Addendum to user manual

To mitigate increasingly stringent risk assessment protocols, the RT-Strut is now supplied with supplementary retaining straps to prevent it moving forwards in the cabin in the event of an accident or collision. While the use of the strap system does not affect performance in any way, we recommend that it is used.

Figure 1. Supplementary Retaining Strap System

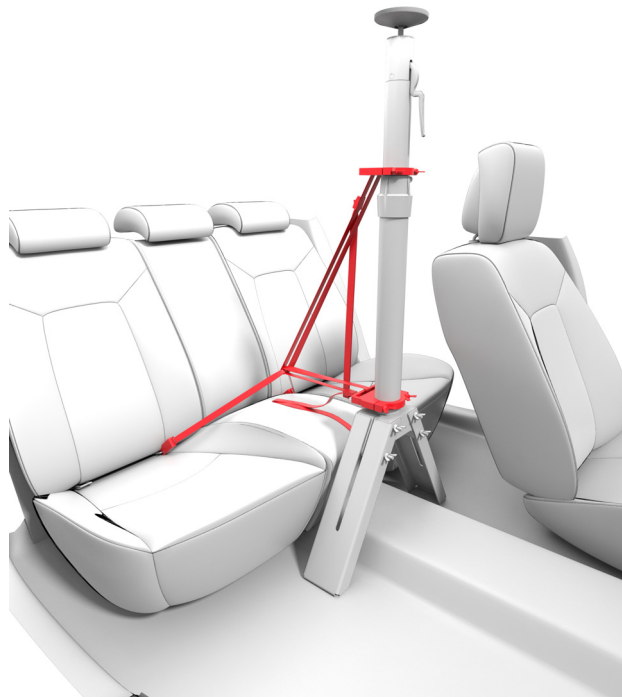
1. The larger diameter clamp should be fixed as low as possible on the bottom tube, while the smaller diameter clamp should be fitted as low as possible on the upper tube. The bolts on each clamp should face forwards.
 2. Clip the ISOFIX strap to the two ISOFIX mounts closest to the RT-Strut. Adjust the strap so that when the main part is pulled, it reaches about half-way to the RT-Strut as shown in Figure 1.
 3. Loop the other straps through the retaining fixtures and the ISOFIX belt as show below. These straps should be adjusted so they are taut, but not so tight that they dislodge the RT-Strut at all.
- . Always perform your own risk assessment and visually check the retaining strap system for signs of wear, prior to each use and replace as appropriate.
